Service Information

Category S	Repair Guidance	Ref. No. R027/13C	Page 1 of 7
Coverage <input type="checkbox"/> Distributor only <input checked="" type="checkbox"/> Please inform your dealers		Date Issued April 4, 2013	
Please convey this information to your <input type="checkbox"/> Director <input checked="" type="checkbox"/> General Manager <input checked="" type="checkbox"/> Warranty Dept. <input checked="" type="checkbox"/> Parts Dept. <input checked="" type="checkbox"/> Training Dept. <input checked="" type="checkbox"/> Field Rep.		Date Revised May 8, 2015	
Applicable Model CX-5 (KE), Mazda3 (BM) and Mazda6 (GJ)		Applicable Countries or Specifications Worldwide

REVISED

Subject: Rattle Noise from Front Door Window Glass

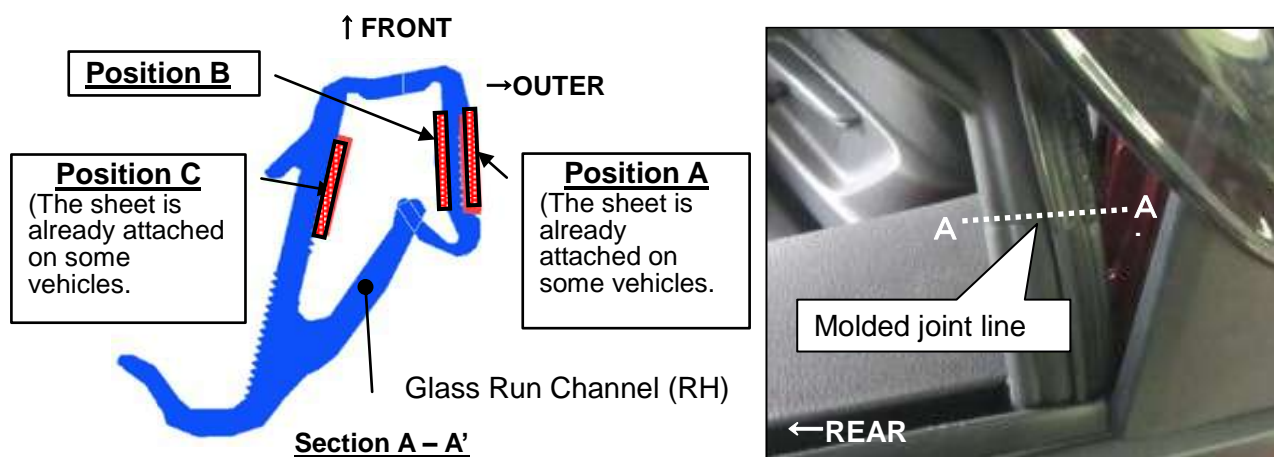
MASS PRODUCTION CHANGE

1. The shape of glass run channel has been changed to increase the holding force.
2. Non-woven fabric sheets have been attached to the glass run channel to increase the holding force.

[POSITIONS TO ATTACH NON-WOVEN FABRIC SHEET]

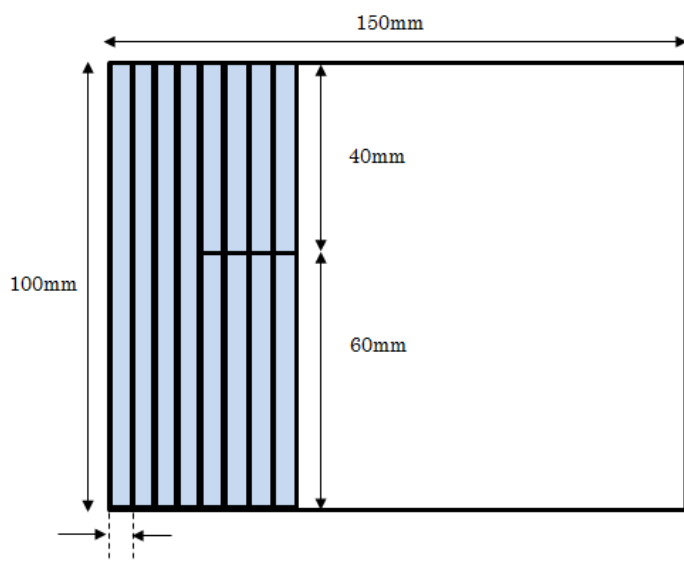
Attach non-woven fabric sheets to Position A, B and C of the glass run channel as shown.

Note: Depending on vehicle types (production change levels), non-woven fabric sheet or resin foam has already been attached to **Position C or Position C & A**. In this case, it is not necessary to additionally attach a non-woven fabric sheet to this position(s).

3-1. Cutting sample

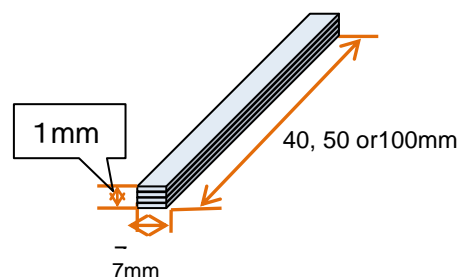
3. Select a non-woven fabric sheet of 0.25mm thickness from the "Noise Parts Set" and cut it into sizes necessary for the vehicle in repair. Select appropriate repair according to above VIN table.

For CX-5 Type A

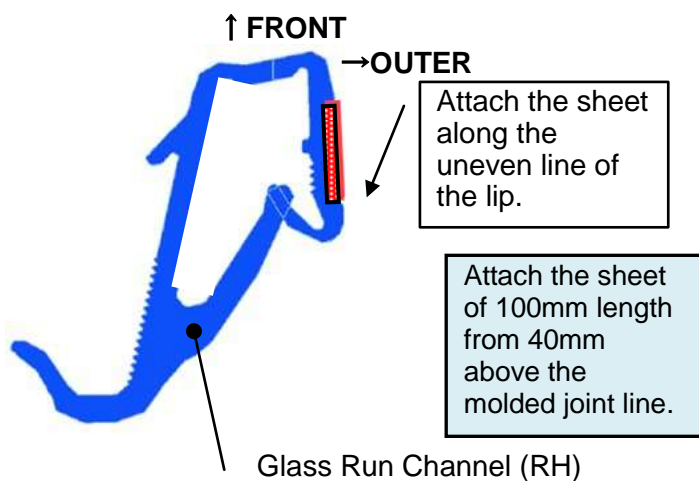
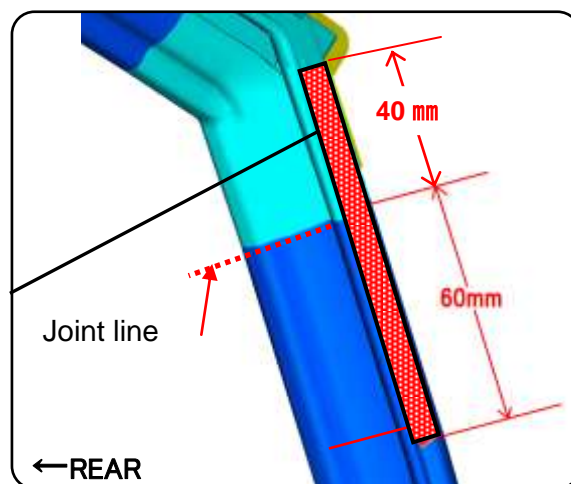
1) Attach the sheet of the below size to **Position A**.

Vehicle Type	Sheet Size (mm)
CX-5 TYPE A:	1x7x100
CX-5 TYPE B:	1x7x40
Mazda3 TYPE B:	1x7x50

For CX-5 Type B

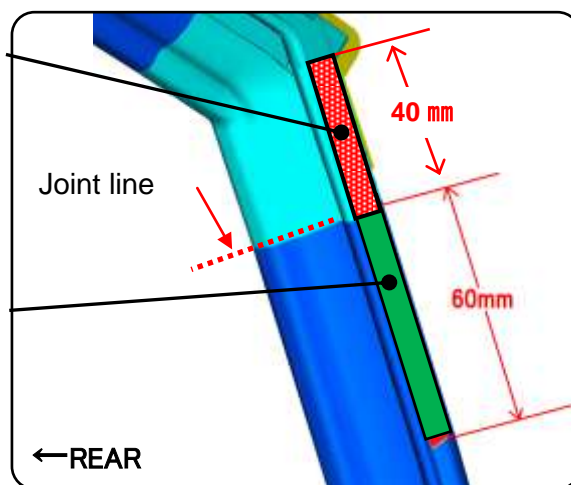
Attach the sheet of 40mm length right above the molded joint line.

This sheet has already been attached to this portion.

For Mazda3 Type B

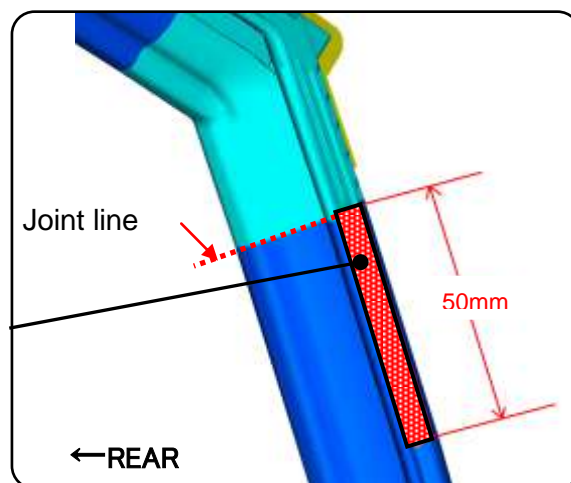
Attach the sheet of 50mm length right below the molded joint line.

For All Vehicle Types

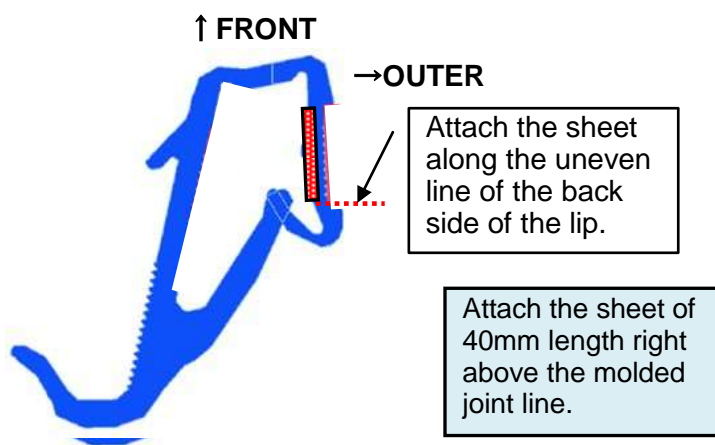
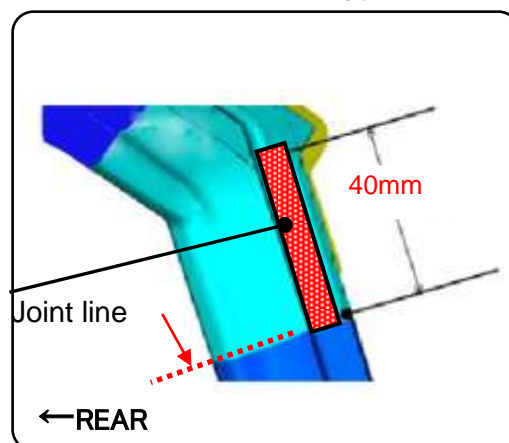
2) Attach the sheet of the below size to **Position B.**

Vehicle Type	Sheet Size (mm)
CX-5 ALL:	1x7x40
Mazda6 ALL:	1x7x40
Mazda3 ALL:	1x7x40

Note: The picture is perspective view. In the actual work, attach the sheet by flipping the outer lip

For CX-5 Type A

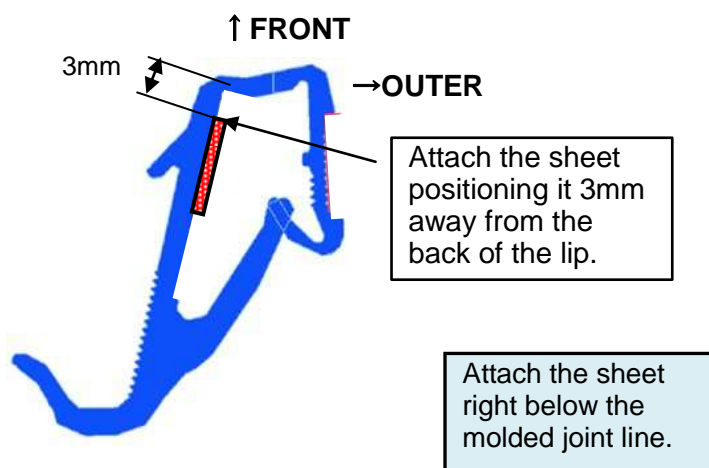
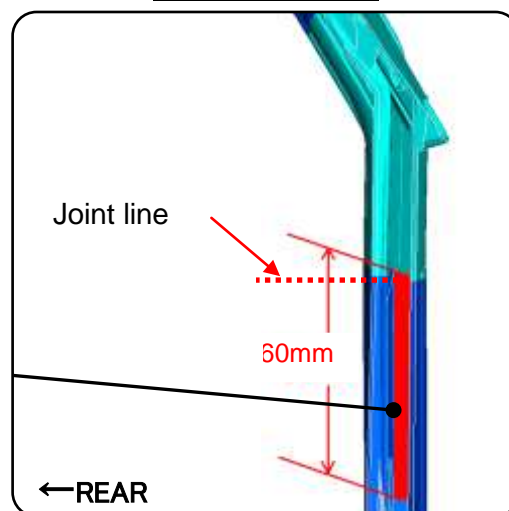
3) Attach the sheet of the below size to **Position C.**

Vehicle Type	Sheet Size (mm)
CX-5 TYPE A:	1x7x60

Note: The picture is perspective view. In the actual work, attach the sheet by flipping the outer lip
